Value Planning – Final Report

Cle Elum Dam Fish Passage Facility

Yakima Project, Washington

July 6, 2009

Figure 1. Proposal No. 1. Use of Spillway as Barrier Dam & Right Bank Fish Facility.

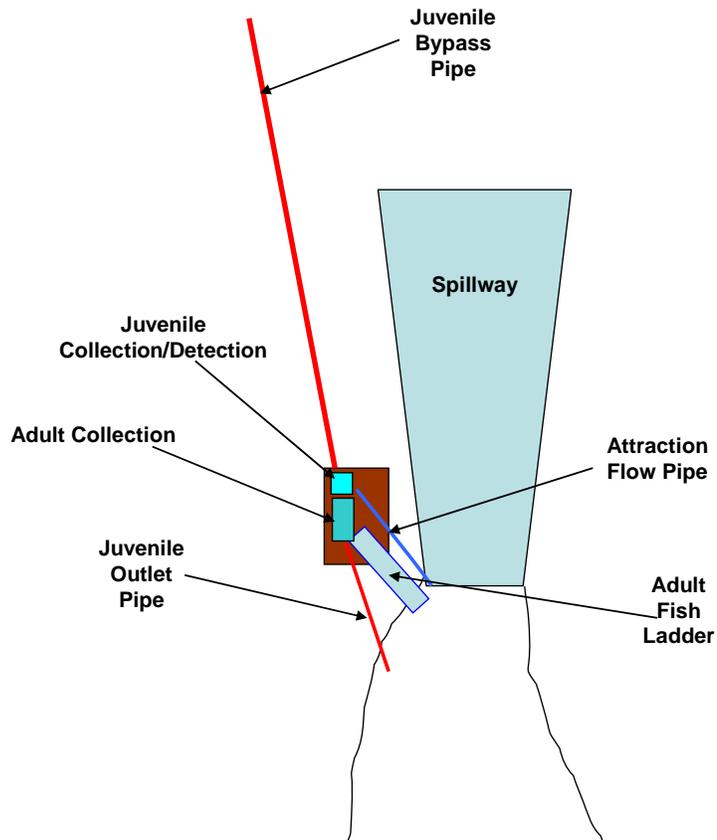
Proposal No. 1. Use of Spillway as Barrier Dam & Right Bank Fish Facility

- Proposal Description: The Cle Elum Dam spillway will function as the barrier to upstream migrating fish. The existing spillway will replace the need for the proposed adult barrier dam, which is angled downstream approximately 150 (left bank) – 300 (right bank) feet. The adult fish ladder and collection facility (AFLCF) will be located on the right bank next to the spillway, sited over the juvenile bypass pipe (see figure 1-1). The fish bypass water will be used to provide flow to the fish ladder and for attraction flow down to reservoir elevation 2190', which extends from mid-March – mid-August for an average water year. Below reservoir elevation 2190' (mid-August – mid-November) flow for fish ladder and attraction flow will be provided by a pump (possibly gravity flow). An additional feature to the facility will be the capability for juvenile sampling (hands-on and Passive Integrated Transponder (PIT) tag detection).

- Changes from the Baseline:
 - Eliminate the fish barrier dam.
 - Move the AFLCF from the left bank to the right bank.
 - Use the fish bypass water to serve flow to the adult fish ladder and for attraction flow when discharge through the juvenile conduit.

- Add stilling basin on the outlet of the bypass pipe to reduce velocities and a fish screen to remove the juveniles.
 - Add juvenile sampling/PIT tag detection capabilities.

- Add a dewatering system for juveniles.

Figure 3-1. Proposed Intake Structure Location

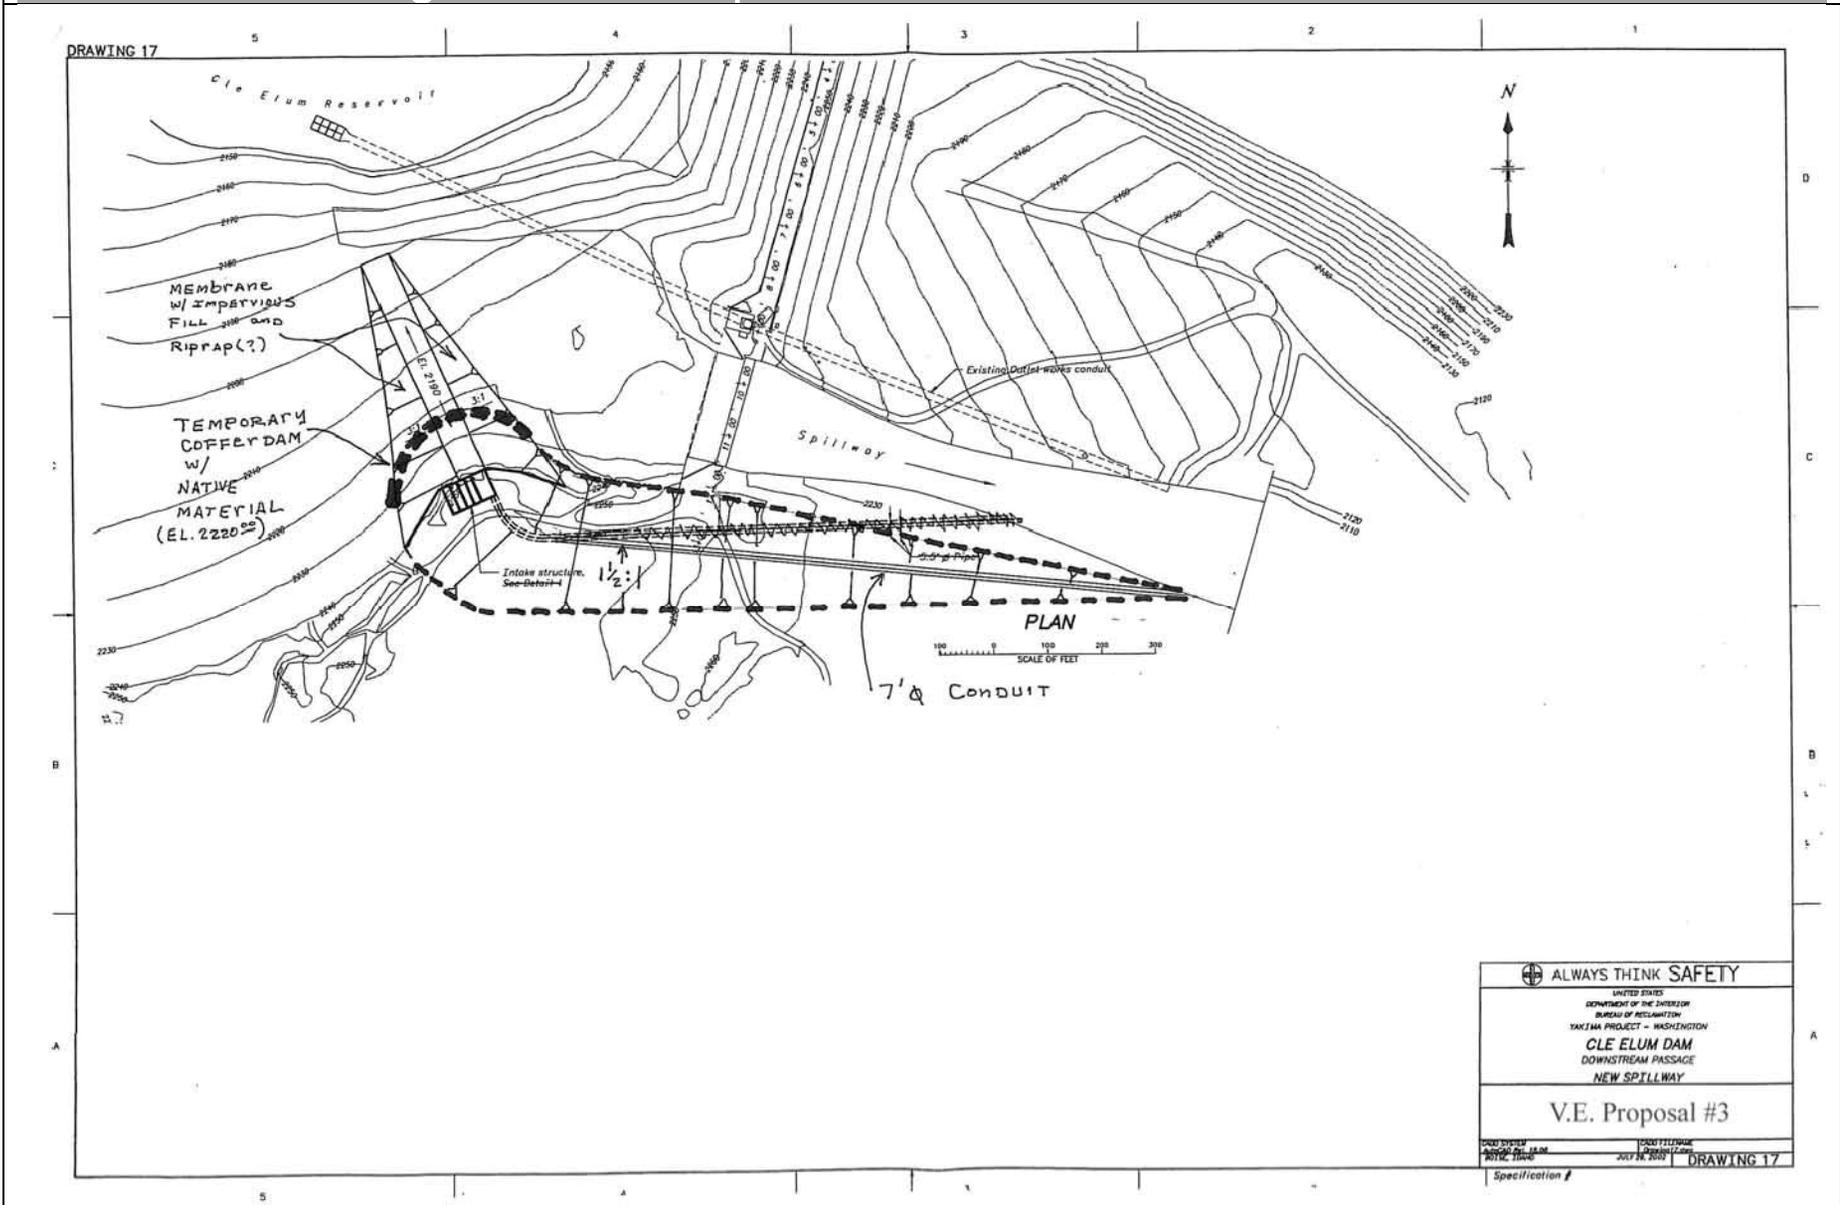
Proposal No. 3 Move Downstream Passage Intake Structure To Shoreline.

- **Proposal Description:** Similar to baseline concept, primary differences include:
 - moving intake closer to the right shore;
 - eliminating the cellular sheetpile cofferdam by performing excavation in a manner that leaves in place native material between the reservoir and the structure excavation to act as a water barrier;
 - eliminating the need for an access bridge;
 - shortening the downstream passage conduit by approximately 400 feet;
 - steepening excavation slopes from 3:1 to 1.5:1; and
 - constructing of an approach channel with an impervious liner and slope protection.

The intake structure design and upstream passage features remain unchanged from baseline concept.

Figure 4-1. Sulphur Creek Wasteway Barrier Designs

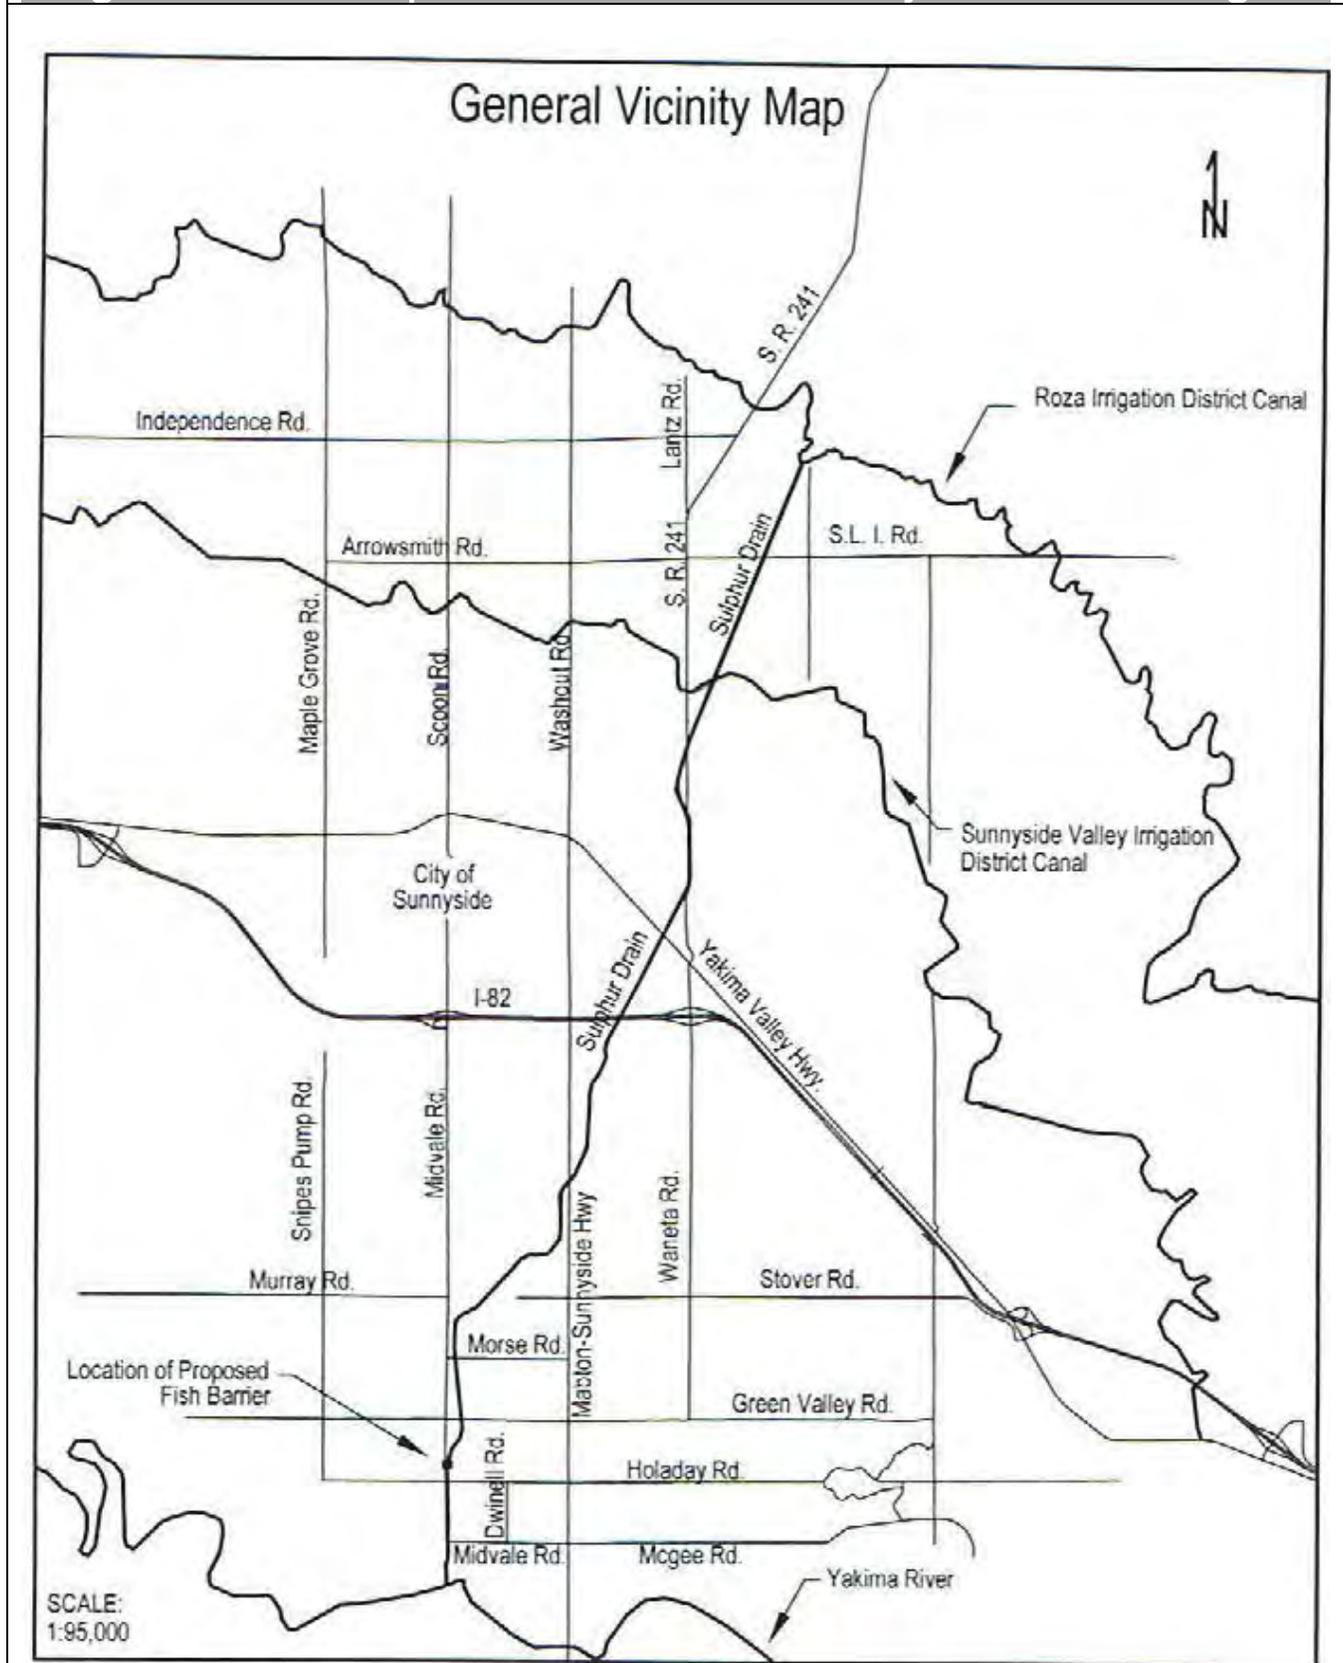
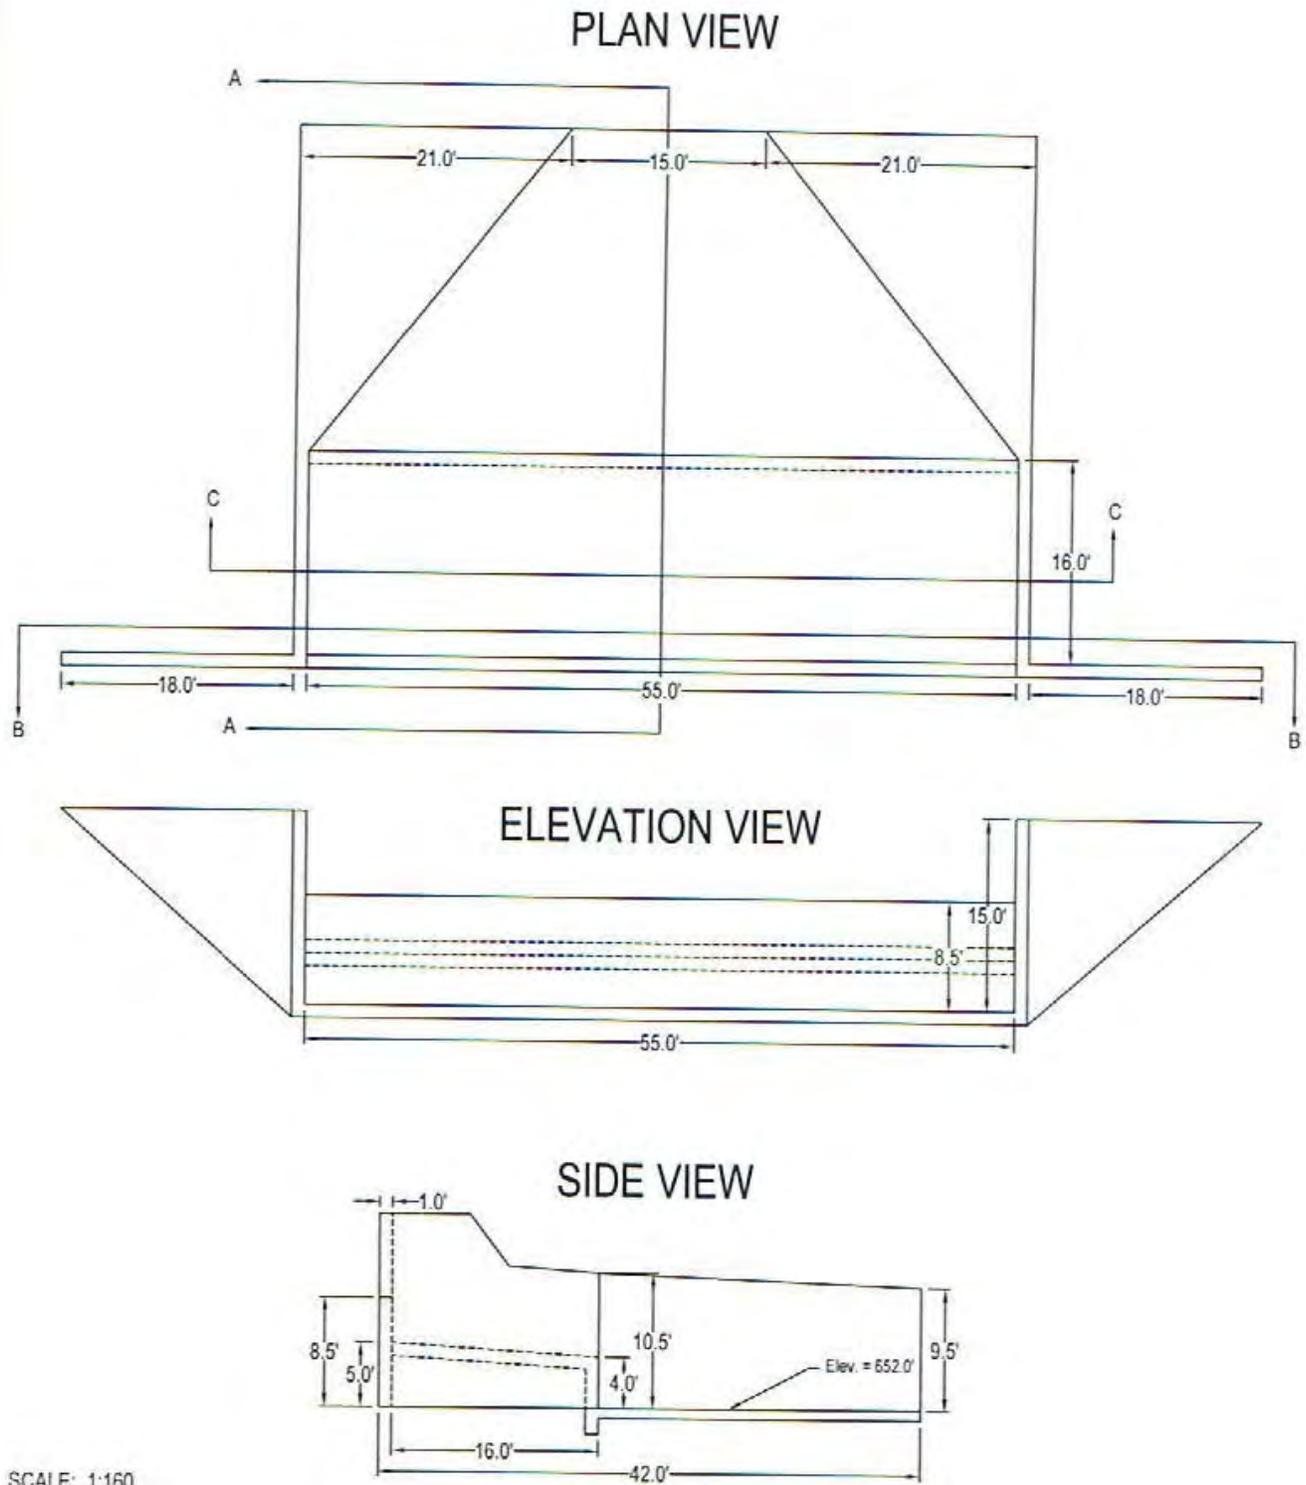
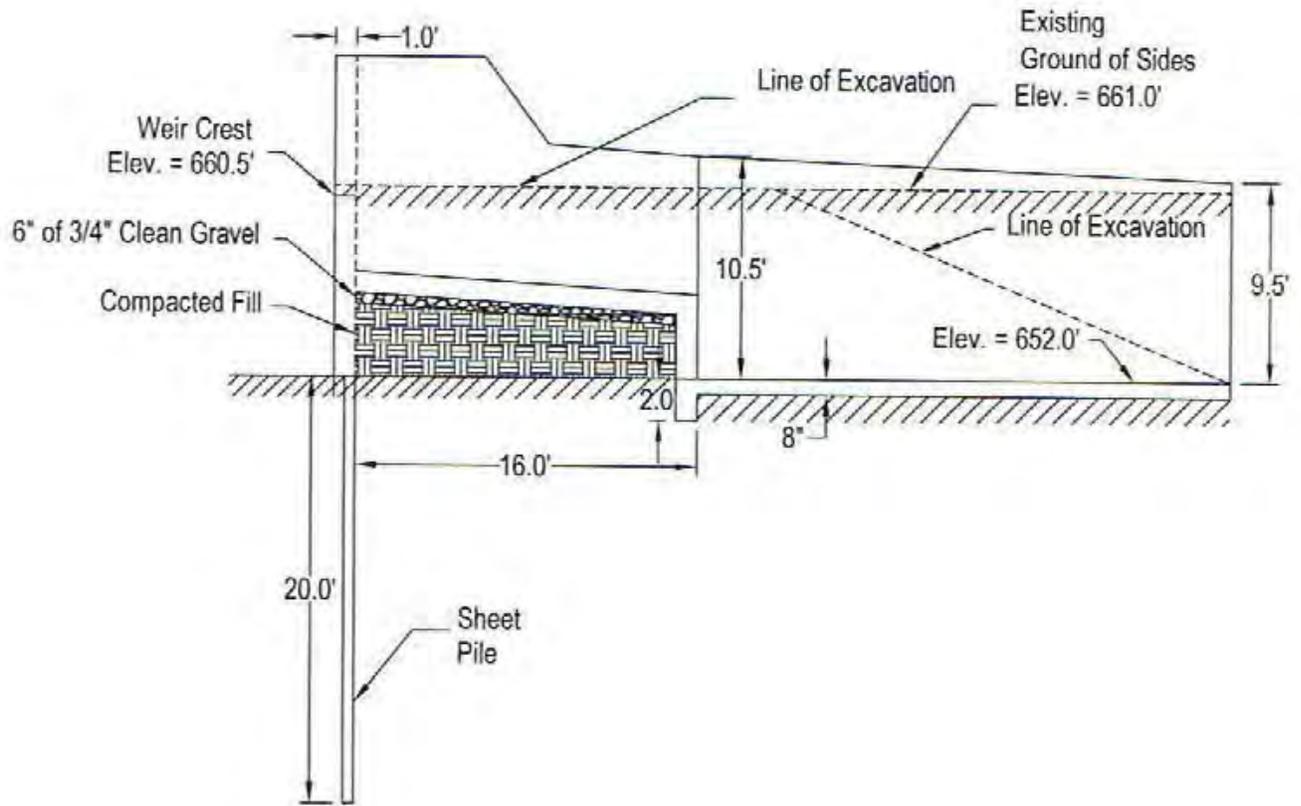
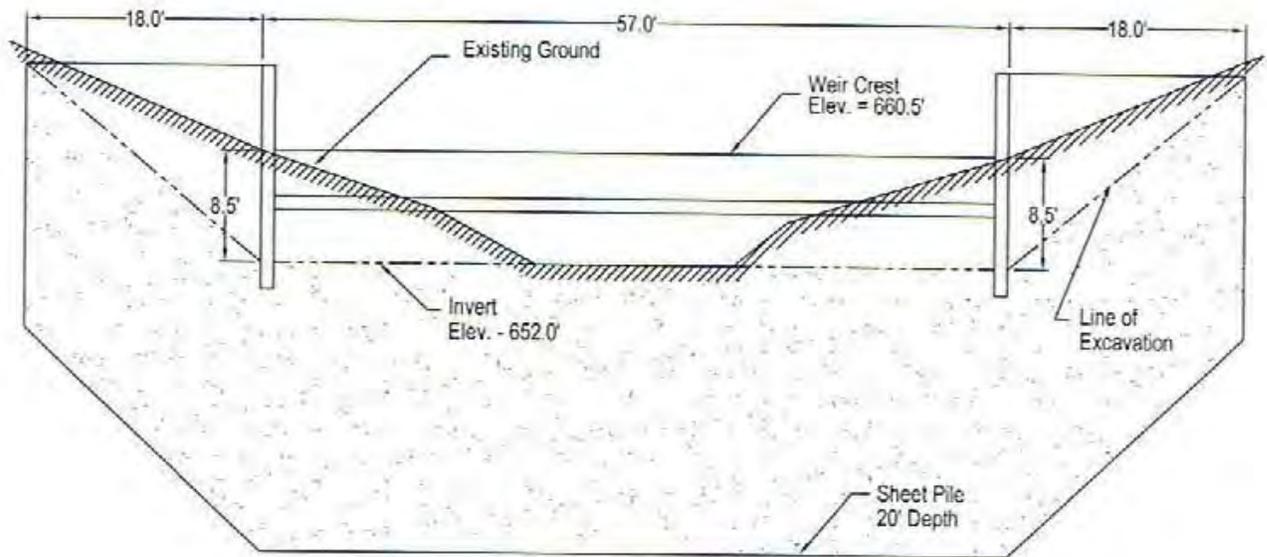
Proposal No. 4 Concrete Fixed Angle Wall Exclusion Weir Barrier Dam
